PLANNING COMMISSION REGULAR HYBRID MEETING

COMMUNITY DEVELOPMENT DEPARTMENT STAFF REPORT TO THE DESIGN REVIEW BOARD

PROJECT: Design Review – Gere Automotive
FILE NO.: DRB22-0009
DATE: October 17, 2022

1
A.07 NORTH ELEVATION
SCALE: 1/4" = 1'-0"

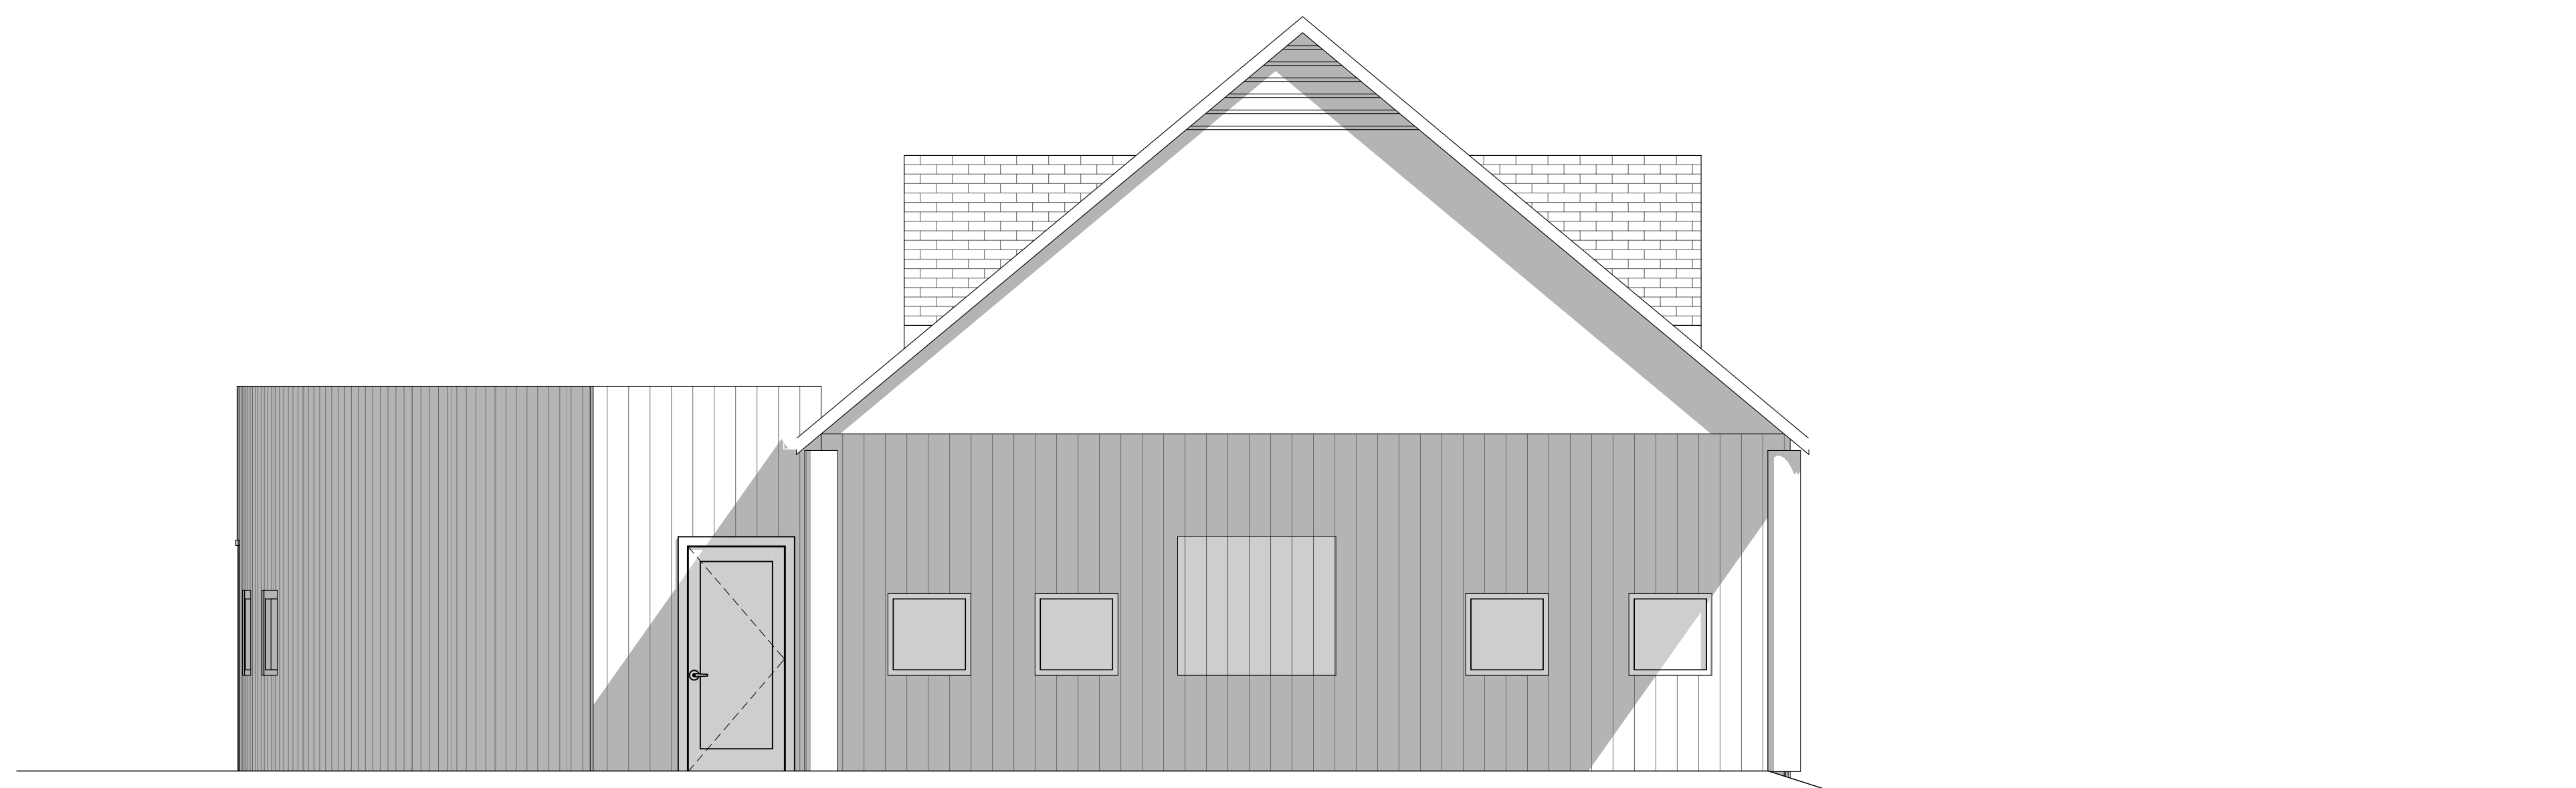
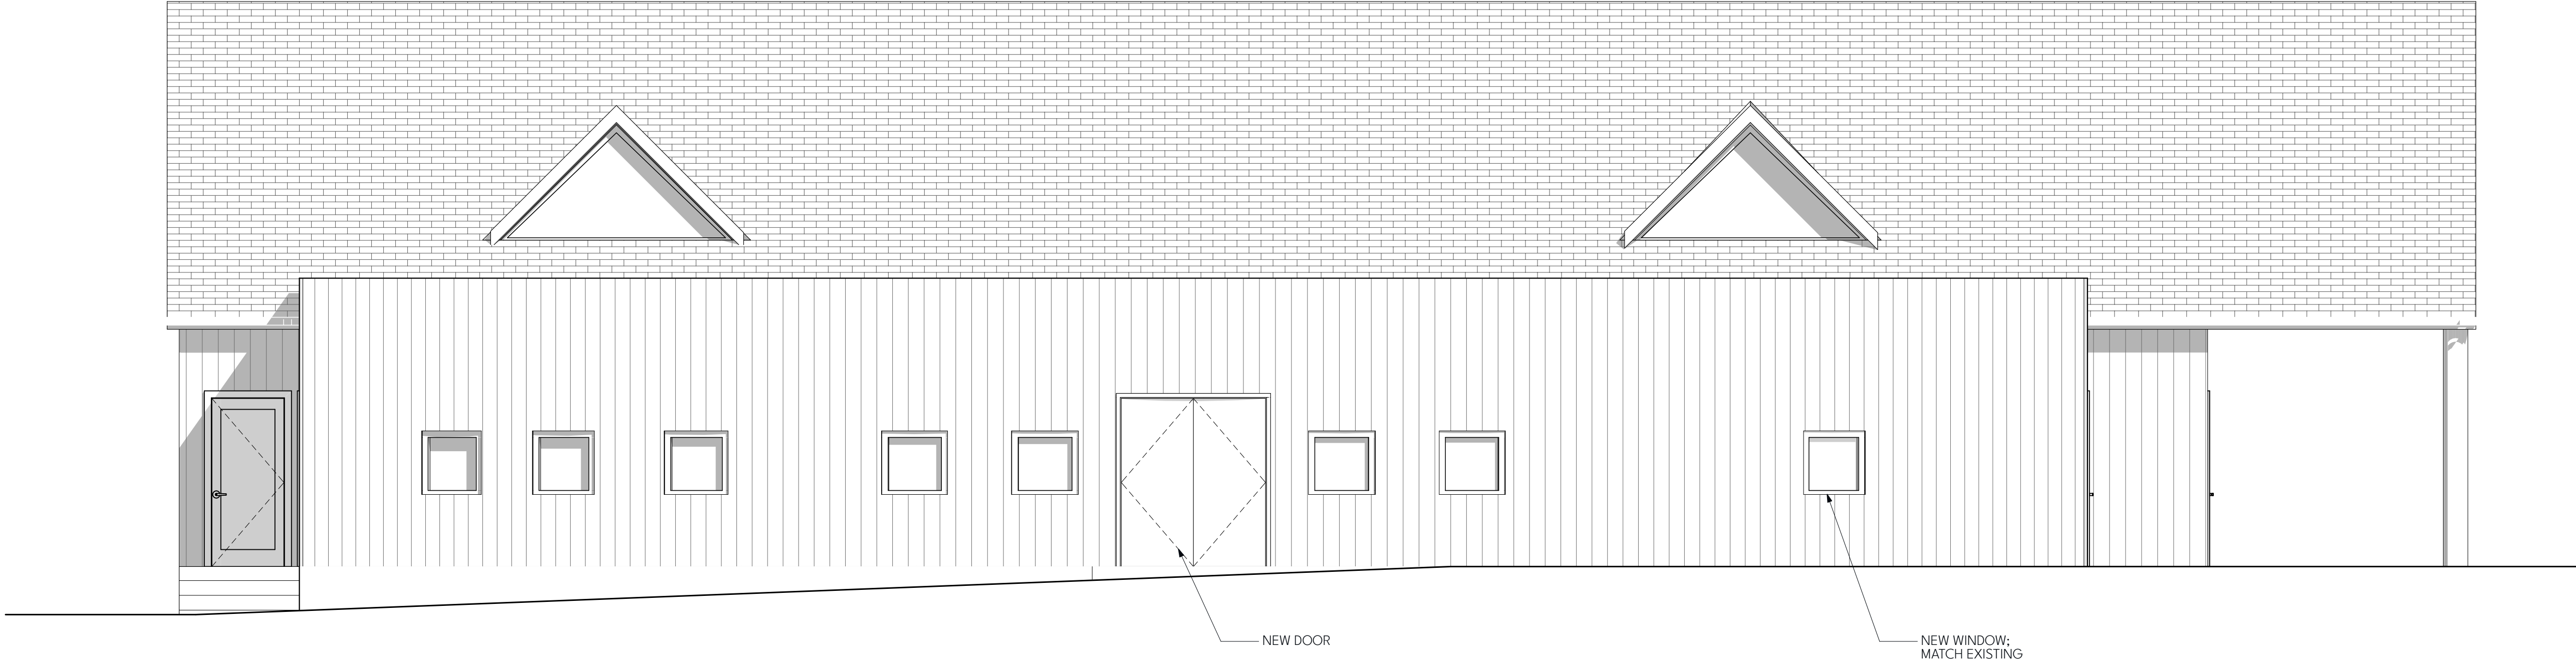
The changes to the existing building will be to add five (5) service bay doors that architecturally resemble a residential paneled garage door. The building will retain its wood frame façade and gable roof which is compatible with the abutting commercial and residential structures in the near vicinity.

According to the building plans, the new service bays at the front of the building are proposed to be paneled-style garage doors providing a variety to the architectural style.

1. The applicant shall obtain a building permit prior to construction.
2. The applicant shall submit proposed lighting designs to the Community Development Director for approval prior to construction.
3. Signage requires separate permit.
